Airways New Zealand submission to the Civil Aviation Authority's 2017 Taranaki Airspace Review

**Prepared by: John Wagtendonk
Policy, Standards and Safety Improvement**

Updated version 4 25 March 2017

This submission requests a reduction in the size of the New Plymouth control zone (NP CTR) and significant changes to the New Plymouth control area (NP CTA). Associated with the NP CTA change, the Auckland CTA/D 6500 ft to 9500 ft (NZA438) and the Christchurch CTA/D 6500 ft to 9500 ft (NZA349) would need to be expanded to the west to match the requested expansion of the NP CTA and provide containment of instrument flight procedures. Other AA CTAs above would also need boundary changes to match the expanded NP CTA.

Diagram 5 Draft PBN STARs to RWY 23 and Draft NP CTA

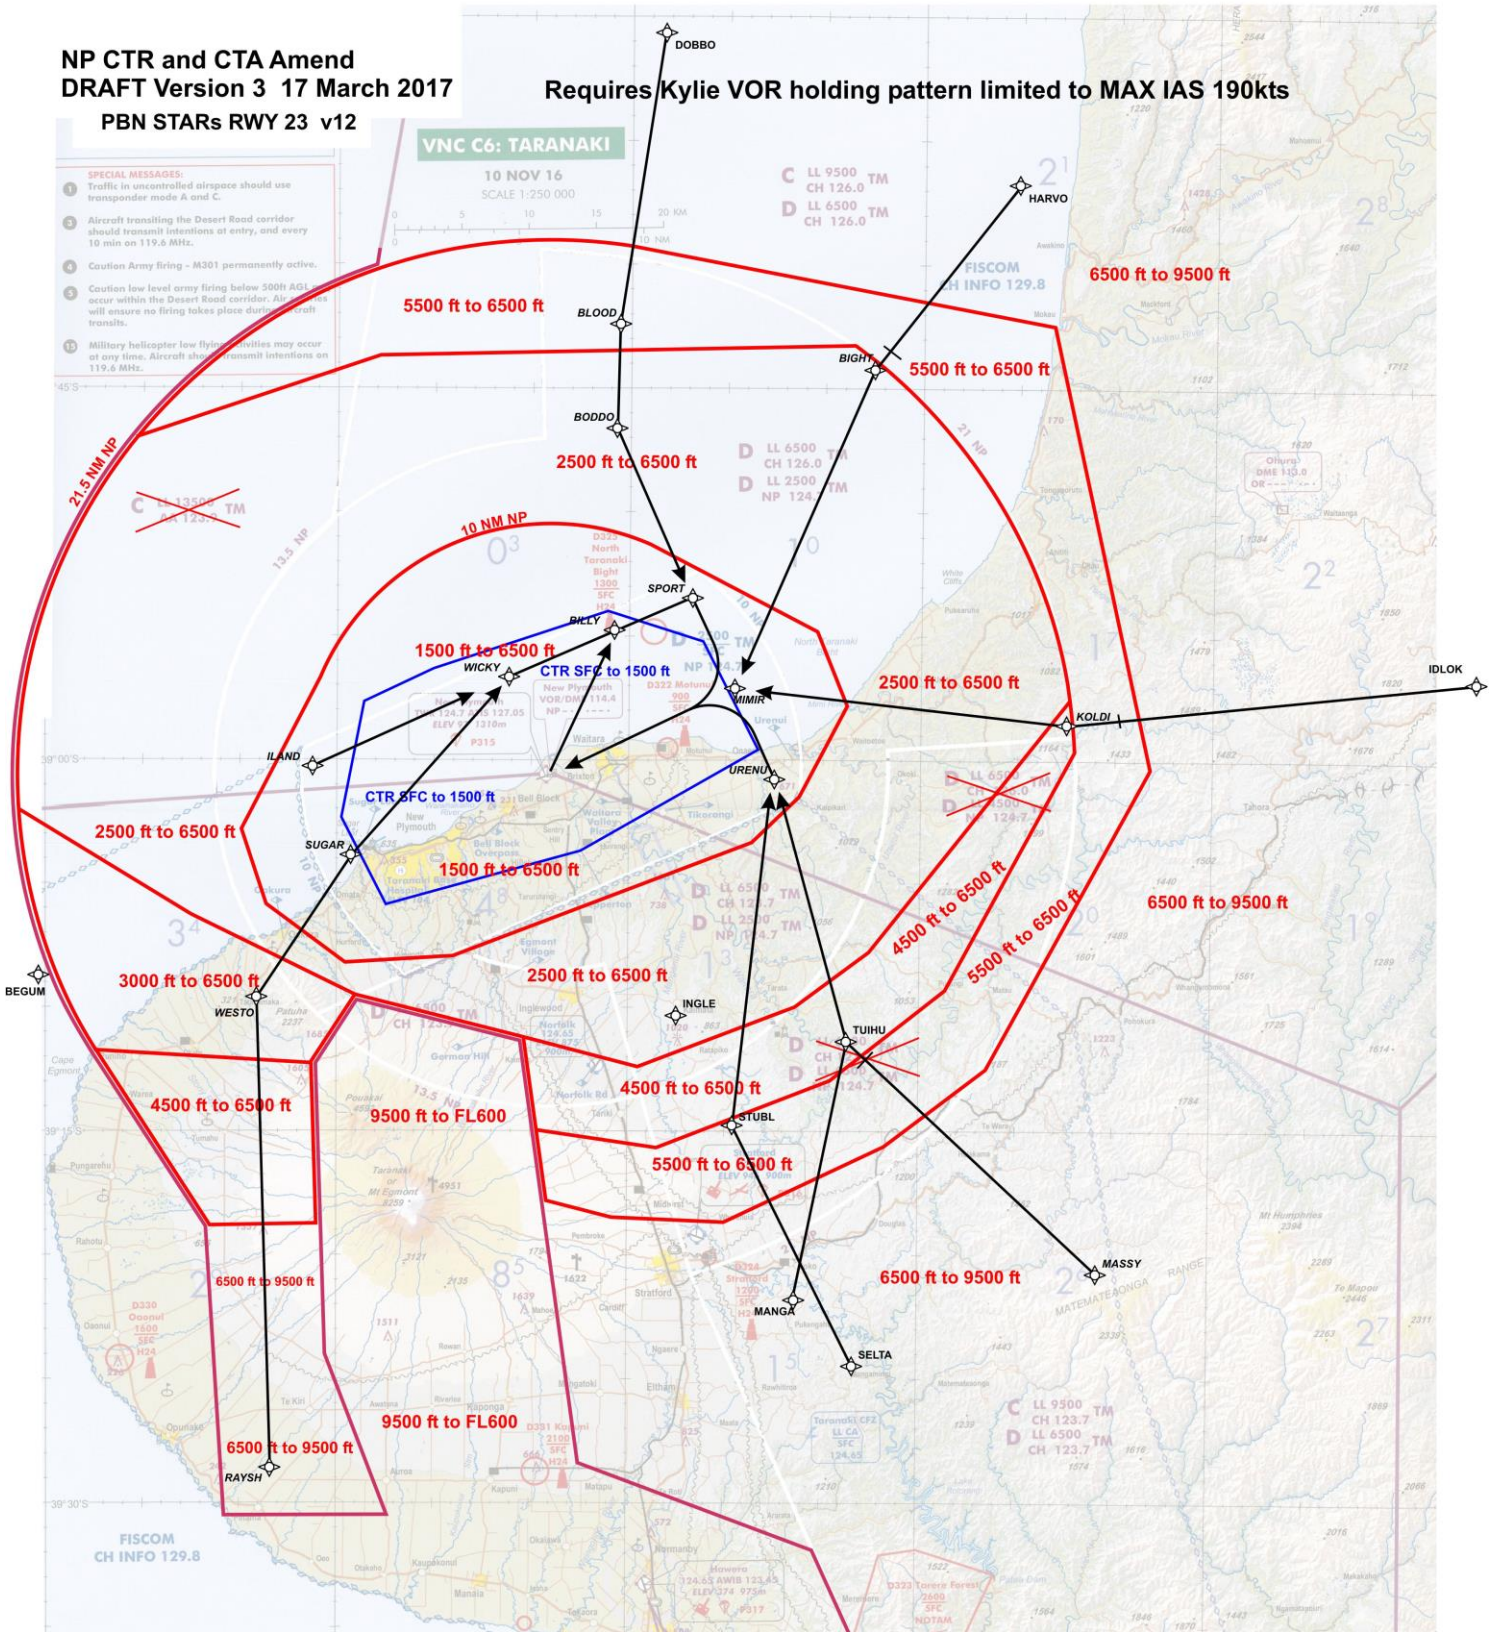
Requires Kylie VOR holding pattern limited to MAX IAS 190kts

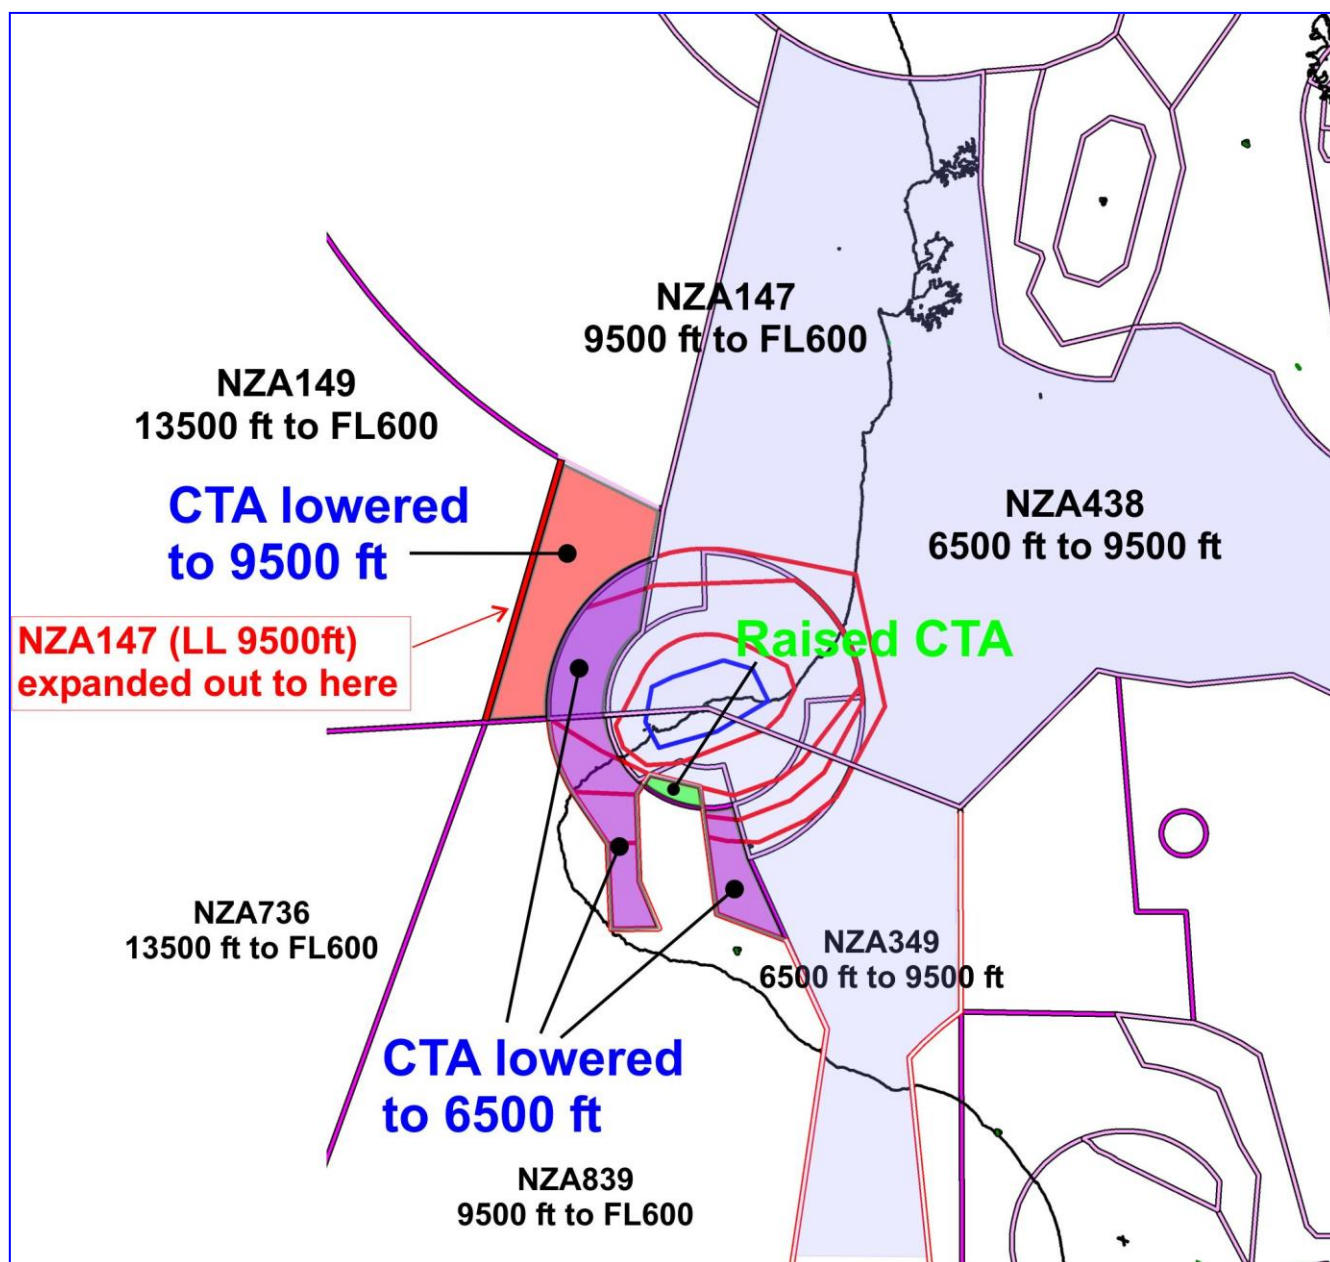
Expanding the NP CTA (up to 6500 ft) to the west and southwest requires that the overlying AA and CH CTAs are also expanded to match as depicted in the diagram below. Those CTAs are;

NZA438 AA CTA/D 6500 ft to 9500 ft; NZA349 CH CTA/D 6500 ft to 9500 ft;
NZA147 AA CTA/C 9500 ft to FL600; NZA149 AA CTA/C 13500 ft to FL600

Additionally, we request a portion of NZA149 is lowered from 13500 ft to 9500 ft. That lowered portion of CTA would be incorporated with NZA147 which has a lower limit of 9500 ft. Effectively, the NZA147 boundary is moved westward by around 15 NM. The new NZA147/NZA149 boundary matches the boundary of the Raglan ATC Sector. It also results in the CTA in the Raglan ATC Sector in that area being a consistent 9500 ft lower limit.
